### NEEDHAM PLANNING BOARD

### Tuesday November 16, 2021 7:00 p.m.

7:20 p.m. Amendment to Major Project Site Plan Special Permit No. 2009-06: Town of Needham, 1471

8:30 p.m. Major Project Site Plan: Needham Enterprises, LLC, 105 Chestnut Street, Suite 28, Needham,

D:\7100S\7185 - NEEDHAM - TOWN COMMON\DRAWI

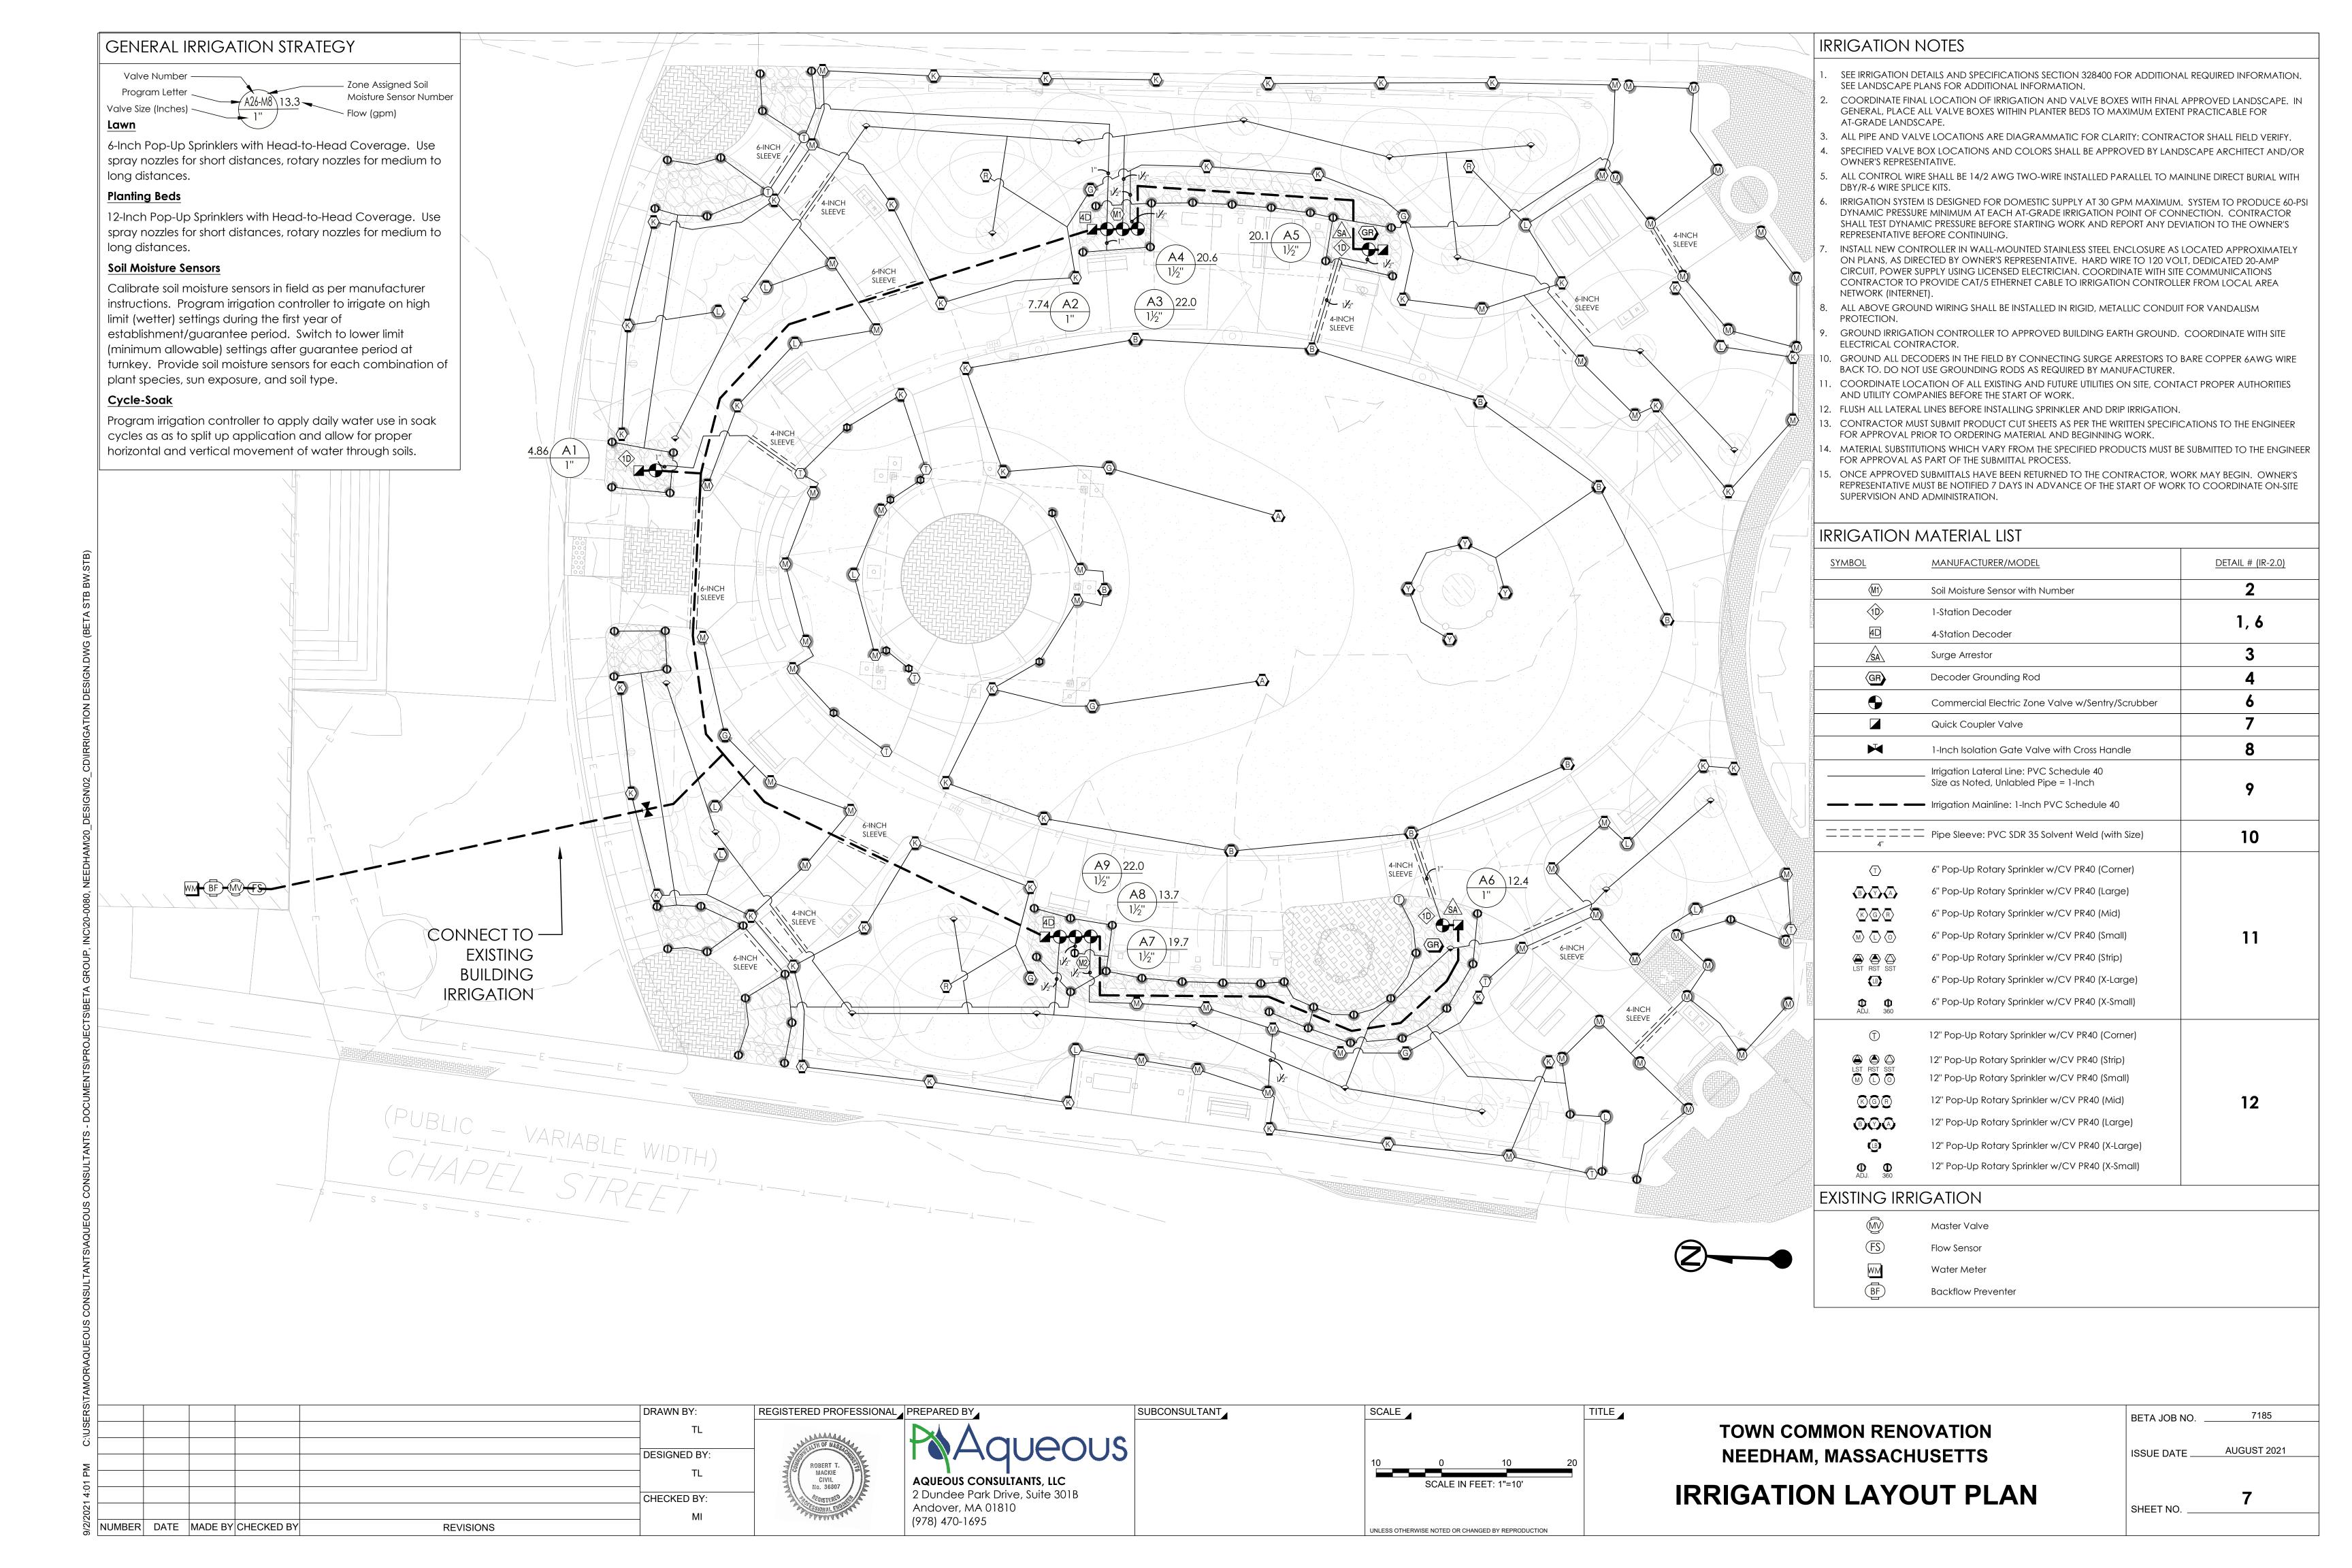
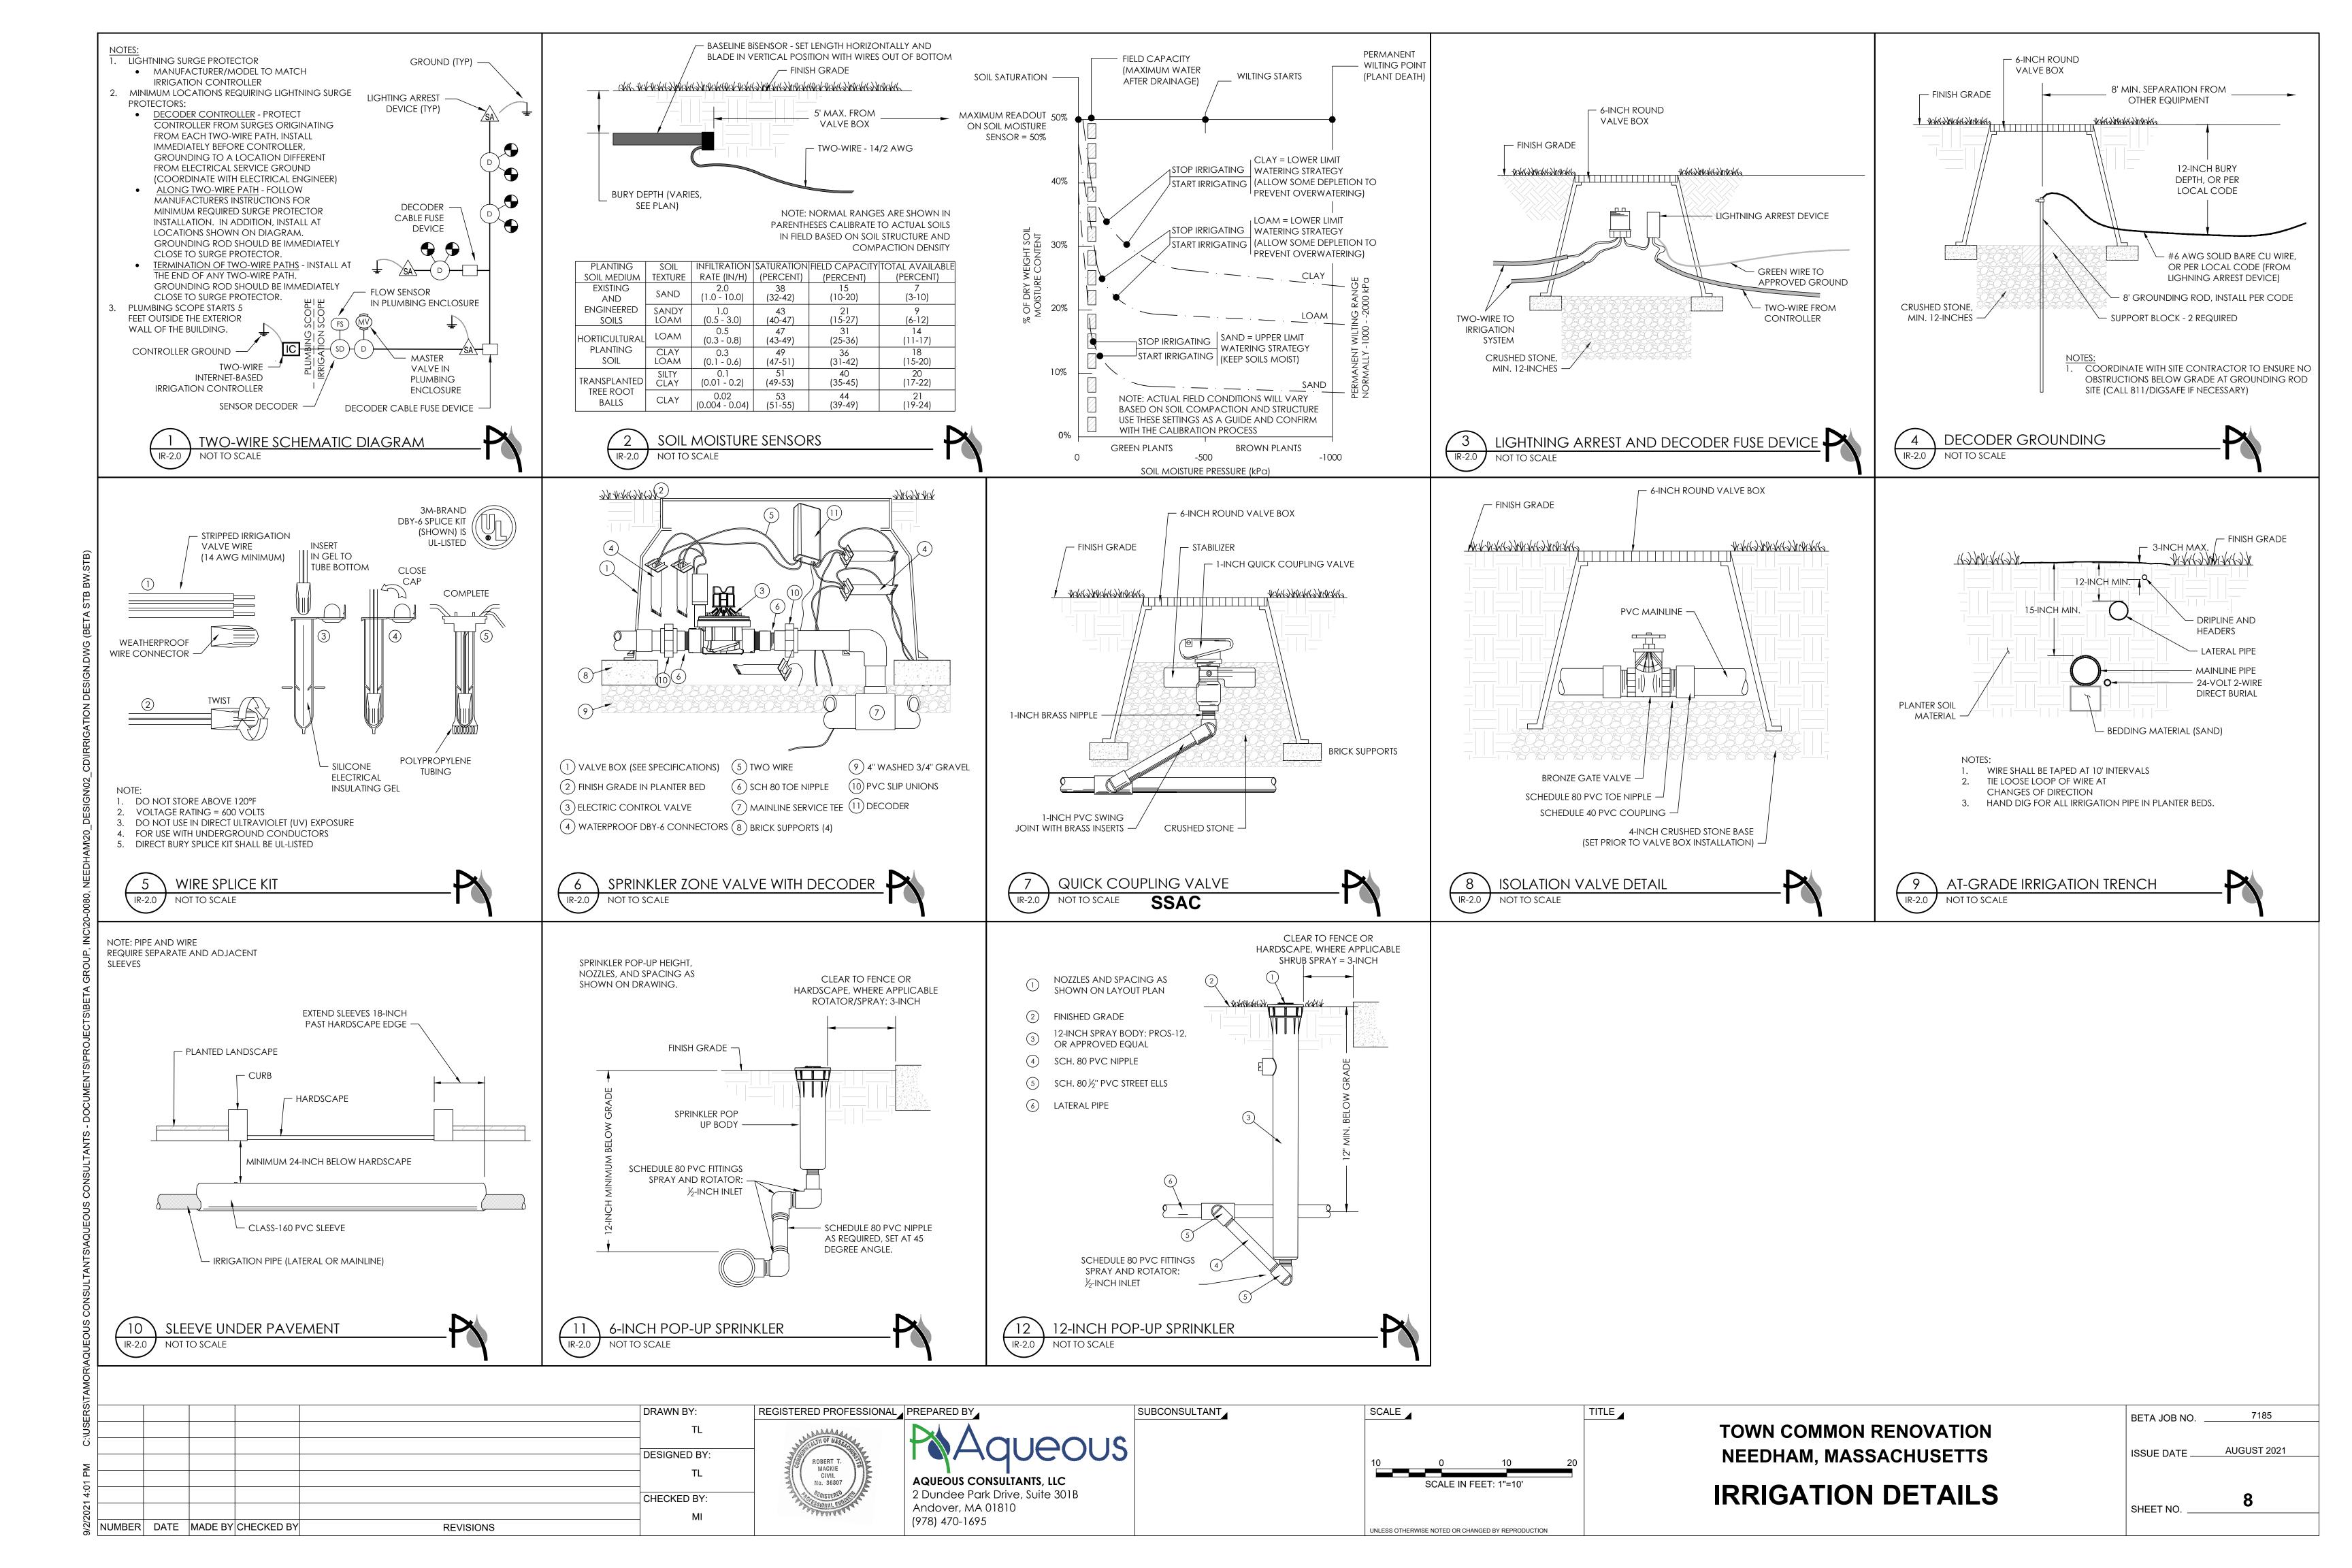
- The brick masonry seat wall at the north end of the site has been redesigned to include brick pillars on each end of the wall. The new pillars have been designed to be similar in appearance to the existing pillars at the end of the walls along Great Plain Avenue. One of the new pillars will be constructed to house PA outlets, wiring, etc. for use during events on the Common. The PA equipment itself will be stored inside Town Hall when not in active use during events. Renderings of the redesigned wall are included as figure (a) below, and on Sheet 12 (Details) of the revised plan set.

- The six (6) temporary festoon poles shown on the original plans have been removed, although the temporary festoon lighting will remain. In place of the free-standing poles, the proposed shade structures located on the east and west sides of the lawn will now include fixtures upon which cables and festoon lights can be affixed. This is illustrated on figure (b) below, and on Sheet 6 (Electrical Plan) of the revised plan set.

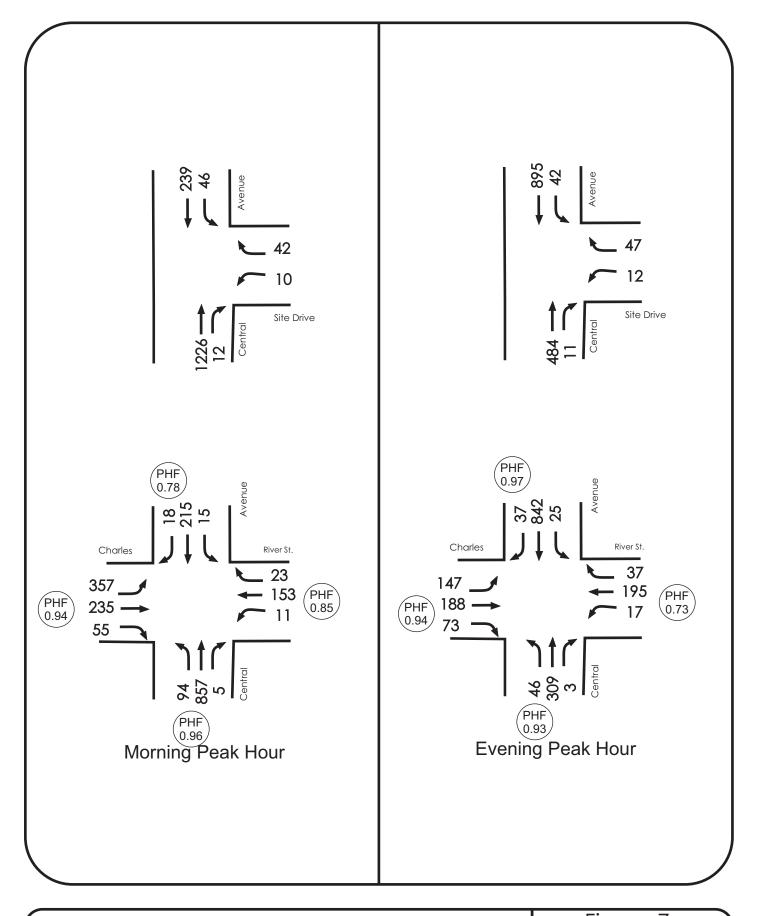
As can be seen on Figure 8, (first two columns) the Central Avenue / Charles River Street intersection currently operates at overall levels of service of "E" during the morning peak hour (7:15 a.m. to 8:15 a.m.) and "D" during the evening peak hour (5:00 p.m. to 6:00 p.m.), assuming roadway network volumes adjusted upwards as described above.

The third and fourth columns in Figure 8 (Base 2028 AM and PM) show level of service projections for this intersection, that are anticipated for 2028 with no development at 1688 Central. These columns project that overall levels of service will worsen somewhat compared to current non-Covid conditions, again, assuming that there is no development at 1688 Central Avenue

The fifth and sixth columns in Figure 8 (entitled Projected Exist. Splits AM and PM) show the projected levels of service in 2028 at this intersection assuming that 1688 Central Ave is developed as Child Care Facility as proposed by the Applicant, but also assuming that no change in the timing of the signalization at the intersection is implemented.

The last two columns on Figure 8 show the projected levels of service at this intersection in 2028 if this site is developed as proposed, and if the timing of the signals is optimized from the perspective of the intersection as a whole. As shown in these two columns, if the changed timing used for these calculations were to be implemented, the overall levels of service (and delays) on Central Ave during peak hours would become significantly better, while the delays and levels of service on Charles River Street would become worse.

The sixth row of data on Figure 8 shows that the 95<sup>th</sup> percentile queue on Central Avenue southbound during the evening peak hour will increase from 830 feet today (with non-Covid traffic volumes) to 907 feet in 2028 without the proposed development of 1688 Central and 950 feet with the proposed development. Thus, comparing 2028 "build" to "no build" conditions projects an increase in the length of the queue during the evening peak hour of about 43 feet (approximately 2-3 vehicles) if this project is developed as proposed.

However since the length of the queue in 2028 is projected to extend past the site driveway under either "build" or "no build" conditions, a change to the timing of the signals at the intersection is called for. As shown on Figure 8 (last row, last column) if traffic signal timing is optimized for the entire intersection, the southbound queue could shorten from 830 feet today to only 670 feet, which is more than 200 feet south of the site driveway. These distances are summarized below:
